NOTICE OF ADOPTED CHANGE TO A COMPREHENSIVE PLAN OR LAND USE REGULATION

Date: March 17, 2016
Jurisdiction: City of Hermiston
Local file no.: 2016 TSP Amendment
DLCD file no.: 001-16

2016 HDJ Transportation System Plan Amendment – March 14, 2016

Re: City of Hermiston Transportation System Plan Update – Ranch and Home Development

FIGURE 2

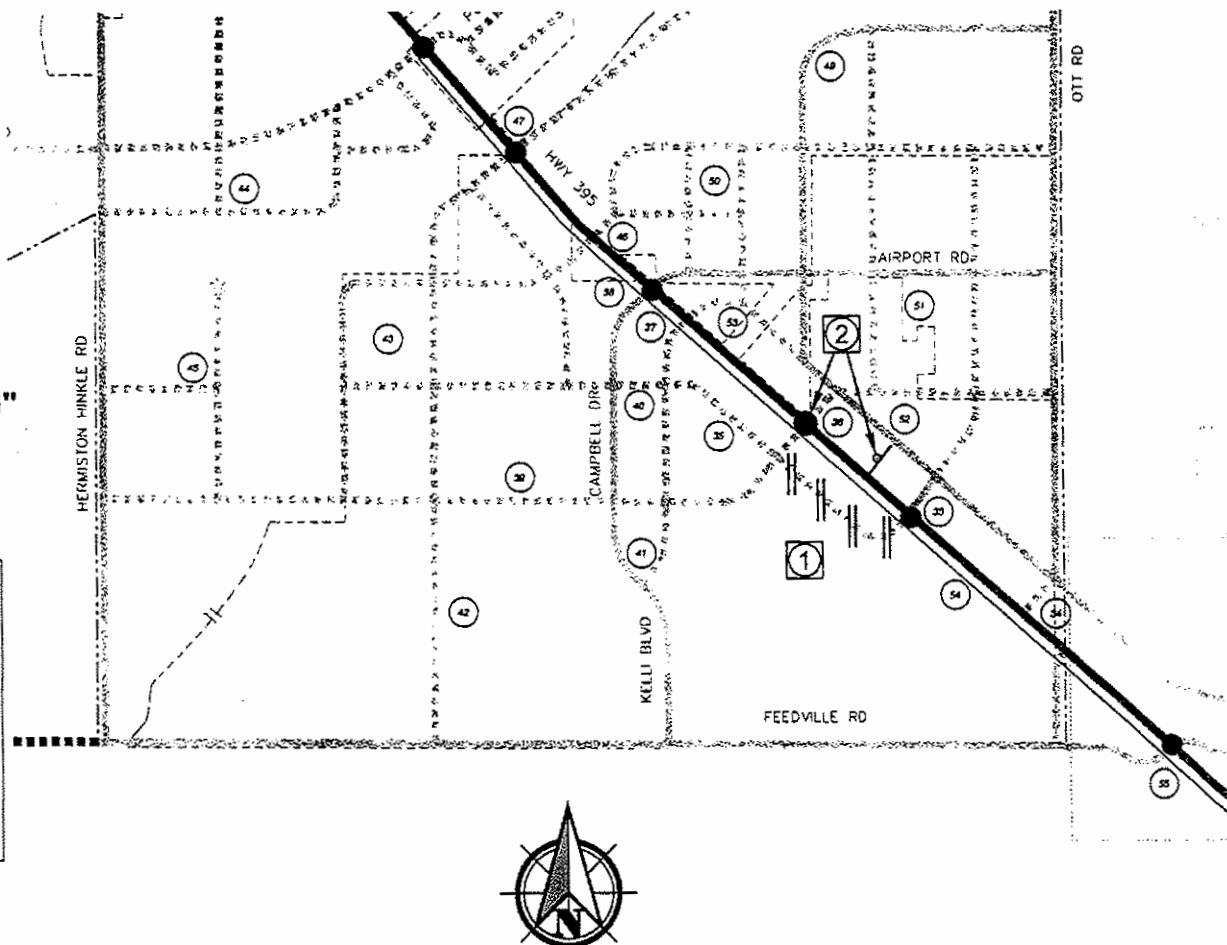
- ① REVISE PROJECT TO SHORTEN 35.
- ② REVISE PROJECT 36 TO INCLUDE FULL ACCESS SIGNAL WITH "PREPARE TO STOP WHEN FLASHING" SIGN.

Revise City of Hermiston's Transportation System Plan listed as follows and illustrated in Figure 1:

1. Modify Project 35--Shorten the proposed minor collector backage road, parallel to US 395, between Kelli Boulevard to the proposed minor arterial listed as Project 39 (Hermiston Foods driveway).
2. Modify Project 36-- Include a full access traffic signal at the proposed minor arterial intersection with US 395, near the Hermiston Foods driveway. With the proposed traffic signal for the Ranch and Home Development and the Hermiston Foods driveway, include an advance warning sign assembly "PREPARE TO STOP WHEN FLASHING" and advance vehicle detection system.

FIGURE 3

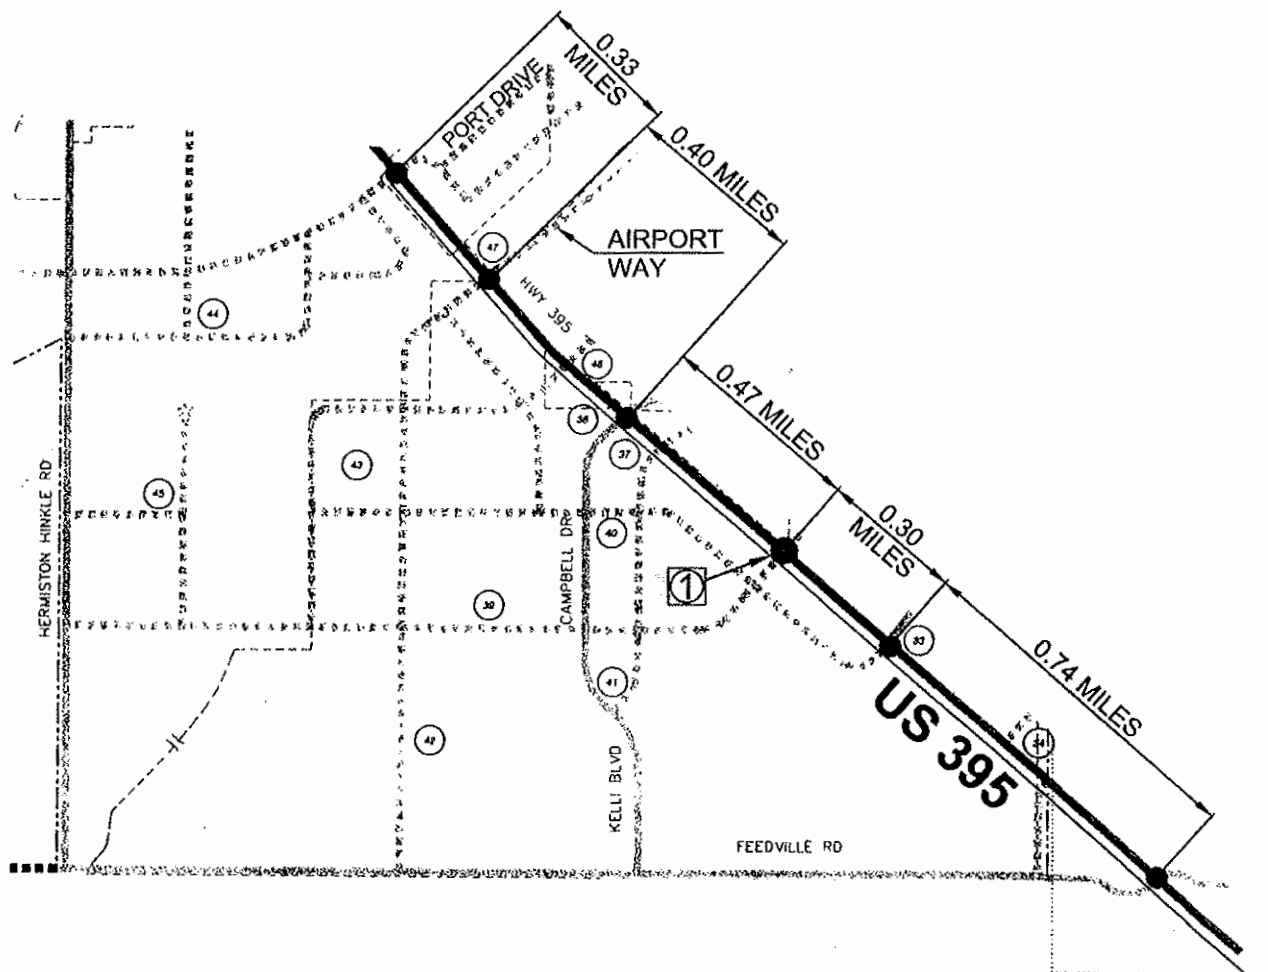
① New traffic signal at Hermiston Foods entrance.
